**Re: Byron Shire Council submission - Cultural Events Site - State significant Development Application (SSD 8169)**

Two concurrent applications are with the Department of Planning and Environment (DPE) for the North Byron Parklands (Parklands) Site.

Map 1. 1 in 5 year flood event.

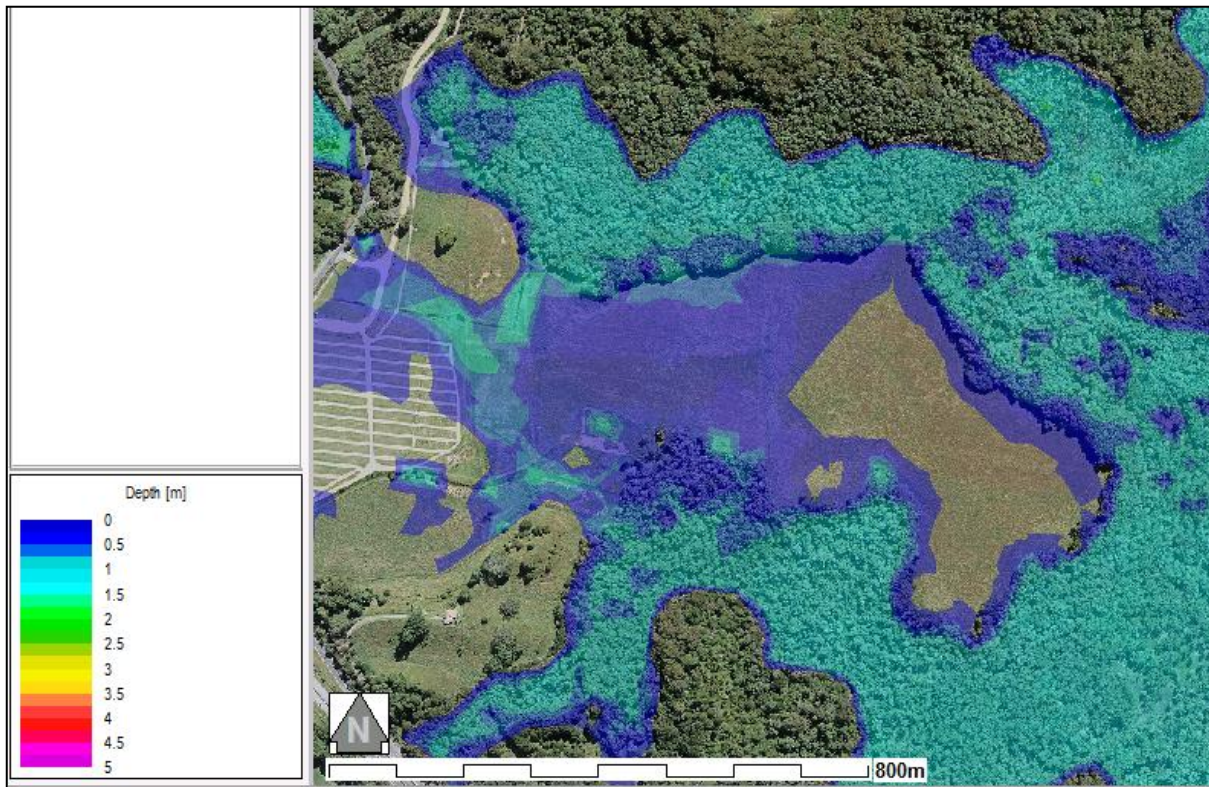
The Department will need to be satisfied the development complies with Clause 24 Development of Flood Liable Land of Byron LEP 1988, which has limitations on filling of flood prone land and Clause 6.3 Flood Planning of Byron LEP 2014 where applicable. Any engineering works in that regard should be carefully modelled so that the full extent on the flood plain can be understood, Ecologically an assessment of the suitability of the site for a car park and environmental impacts on threatened species and in particular wallum frog species is recommended, with the proposed car park area being predominantly within a buffer to SEPP 14 Wetlands and as mapped by the Draft Coastal Management SEPP.
